SERVICE LETTER

No. 758

Piper Aircraft Corporation

Inspection of Bendix Ignition Switches (Rotary Action, Key of Lever Actuated, Twist to Start, Push to Start, Twist to Start/Push to Prime Types). Reference: Bendix Electrical Components Division, Service Bulletin No. 583 (copy attached).

Figure 1. Identification of Switch Parts.

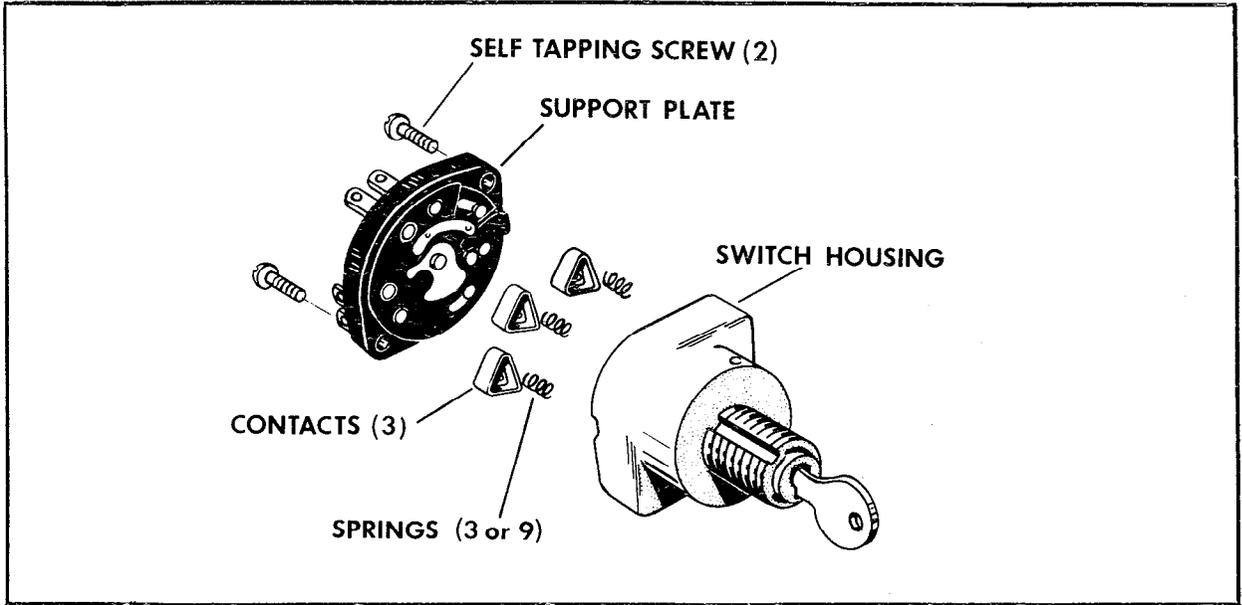
B. To install a new Support Plate and Contacts, proceed as follows using Figure 1 as a guide for parts identification.

- a. Hold switch in a vertical position, support plate up.
- b. Using firm finger pressure, hold the support plate against the switch housing while removing the two self tapping screws. Retain screws for use during reassembly.

- c. Directly beneath the support plate are three contacts, spring loaded against the support plate. Carefully separate the support plate from the main switch assembly and remove the three contacts and springs (3 or 9).
- d. Retain the springs for use during reassembly. Discard old support plate and contacts.
- e. Inspect remainder of switch assembly for smoothness of operation

- a. Apply a light coating of Beacon P-290* non-conductive grease or equivalent to contact surfaces, contact wells in rotor and insulating surfaces over which contacts slide.
- b. Reinstall contact loading springs (3 or 9) in rotor. Position new contacts over springs so contacts will move into triangular recesses when pressure is applied.
- c. Locate boss on new support plate over locating slot in switch housing

and carefully install support plate to housing, observing that contacts move into recesses.

- d. Holding plate against housing, turn key or lever through all switch positions. If it does not turn freely through the detent positions, recheck contact, springs, and support assembly.
- e. Once switch operation is satisfactory, reinstall and tighten self tapping screws holding support plate to switch housing.
- f. After switch has been completely reassembled, check it for ease of operation. There shall be little or no drag between stops. Check for positive stops in all positions. Check switch action for a positive and free spring return from the "START" position to the "BOTH" position. The switch shall not
